QUALITY AUDIT

**Title: QUALITY AUDIT
For;
Proposed Moygaddy Castle SHD**

Report reference: 1577R01

VERSION: FINAL (22-8-2022)

3.1 Issue

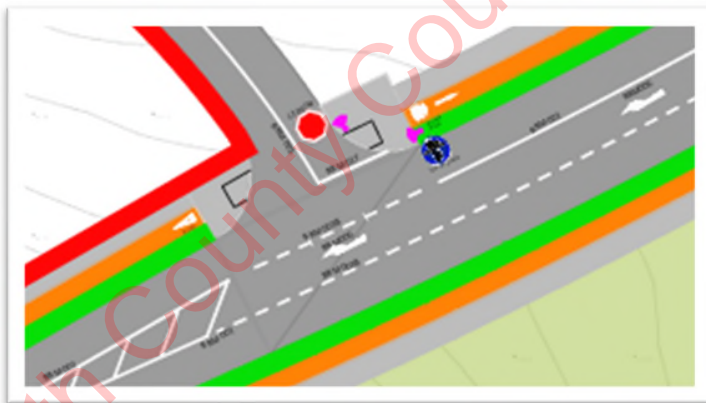
Drawing S665-OCSC-1C-MH-DR-C-0111 S4 P04, MOOR

Both junctions on the MOOR extension are simple priority junctions. There are no facilities for pedestrians or cyclists to cross from one side to the other.

It is recommended that crossing facilities be provided for vulnerable road users.

3.1	Yes	Yes	Toucan Crossing to be added with Detailed design on the MOOR north of the junction with the L6219 (Eastern)	Yes
3.2	Yes	No	The red line has been adjusted to take account of verge requirements for forward visibility. Pedestrian and cyclist infrastructure will be provided along this road as part of the future development of this part of the masterplan lands.	Yes

3.2 Issue

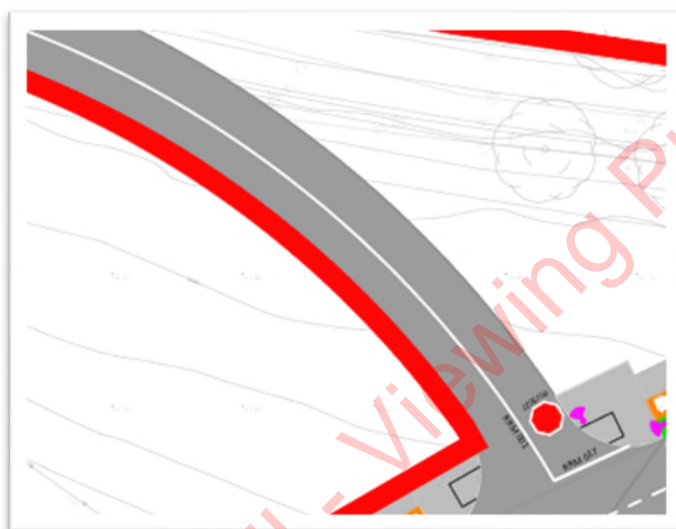
Drawing S665-OCSC-1C-MH-DR-C-0111 S4 P04, MOOR

The tie-in with the existing L2214-3 and the realigned L2214-3 is shown to be constructed tight to the land boundary. This may leave no room for refuge in a verge or footpath for pedestrians. This could lead to collisions with vehicular traffic,

It is recommended that that a suitable verge width be provided.

It is also recommended that the footpaths be returned around the sideroad of the junction of the western tie-in as far as a suitable transition point for transfer to on-road pedestrians.

3.4 Issue

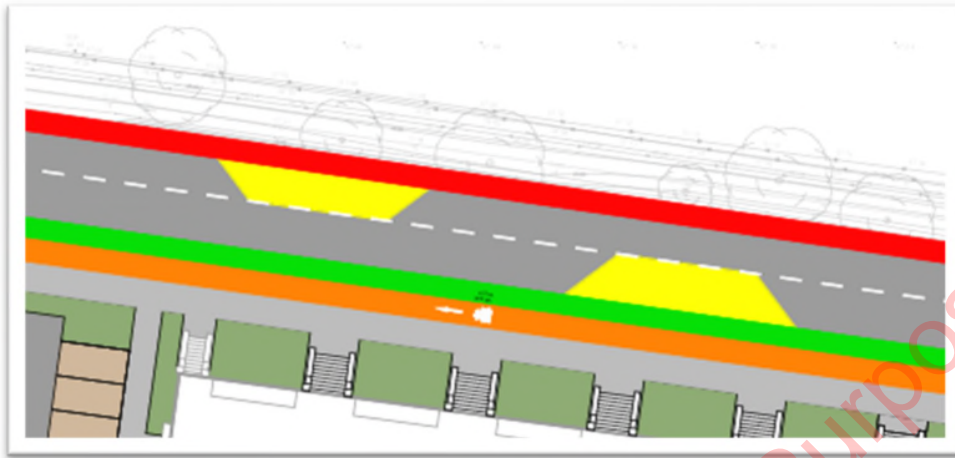
S665-OCSC-1C-MH-DR-C-0112 S4 P04, L2214-3

It is proposed to provide two chicanes on the L4413 as a means of providing traffic calming. It is anticipated that this will be a relatively heavily trafficked link/arterial road and this type of traffic calming may not be appropriate as approach speeds may be too high and this could lead to head on collisions.

It is recommended that more appropriate traffic calming measures be provided to suit the nature of the road.

3.4	No	No	The chicanes will not be installed until the MOOR is complete, and the purpose is to deter through vehicles from using the L6219 in favour of the MOOR.	Yes

3.5 Issue

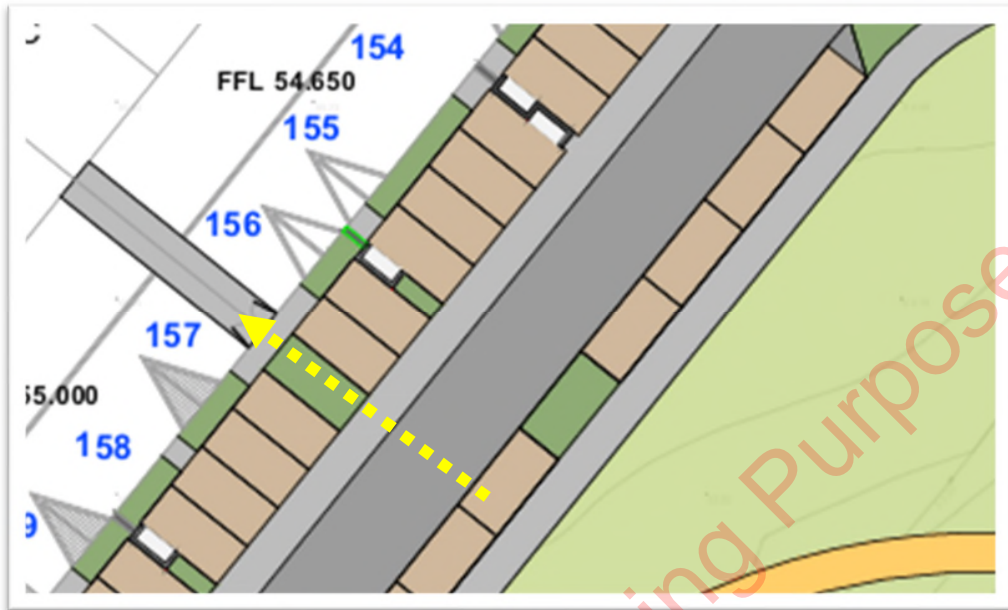
Throughout the development.

It is unclear if access to some residential units will be feasible for visitors if all the parking spaces are occupied. It appears that there are landscaped areas between parking spaces and along the front of the units.

It is recommended that access routes for pedestrians be provided assuming that all parking spaces are occupied.

3.5	Yes	Yes	The current driveway positions are wider than the required minimum as part of Part M. 1.2m access routes will be provided to all front doors as part of the Detailed Design stage of this development.	Yes

3.6 Issue

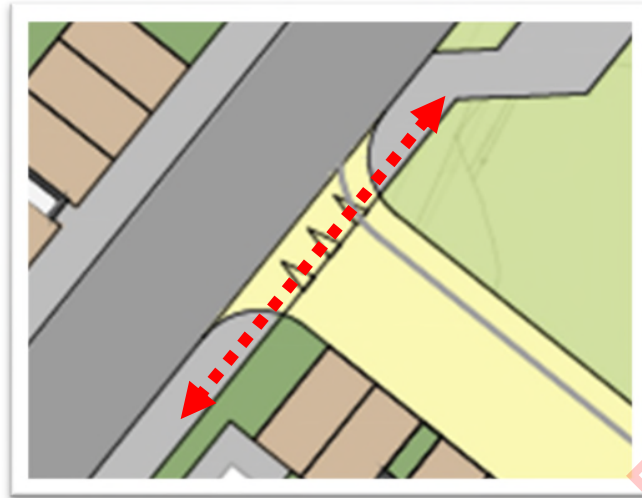
Throughout the development, Shared streets.

Shared streets are generally proposed to be raised to distinguish them from other streets. The tapers at some of the shared streets however coincide with the crossing area for pedestrians on the footpath. The steep gradients of the tapers could lead to instability for the mobility impaired and lead to falls.

It is recommended that the cross fall on the tapers be acceptable for all pedestrians users.

3.6	Yes	Yes	Taper length to be adjust as part of detailed design stage to be acceptable for pedestrians.	Yes

3.7 Issue

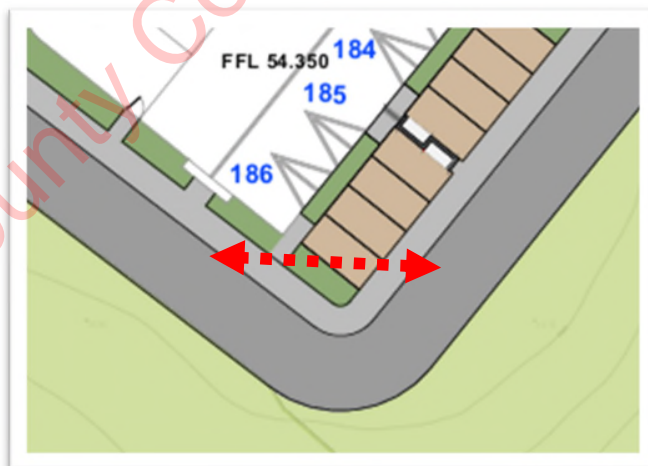
Drawing S665-OCSC-1C-MH-DR-C-0113 S4 P04.

There is a 90 degree bend at unit 186 in the south west corner of the development. It is unclear if suitable stopping sight distance will be provided due to landscaping and perpendicular car parking. A lack of visibility could lead to collisions with oncoming vehicles or hazards on the carriageway.

Ensure suitable stopping sight distance is available at this and other tight radii bends.

3.7	Yes	Yes	OCSC have checked the visibility and are satisfied that subject to low planting only in the landscaped area visibility is maintained appropriately.	Yes
3.8	Yes	No	Field is within the developer owned land. The developer has confirmed that his access is not in-use and will be closed as part of this development. Access will be given through the adjacent field to the west.	Yes

3.8 Issue

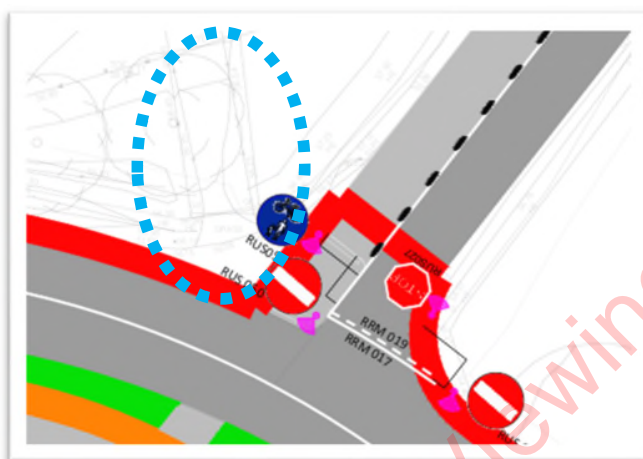
Drawing S665-OCSC-1C-MH-DR-C-0114 S4 P04. L2214 Junction.

There is an agricultural access at the L2214 junction which has limited visibility. It is unclear if vehicles will be able to enter/exit this access safely given the proposed works.

Ensure the access is accommodated for and that suitable visibility is provided.
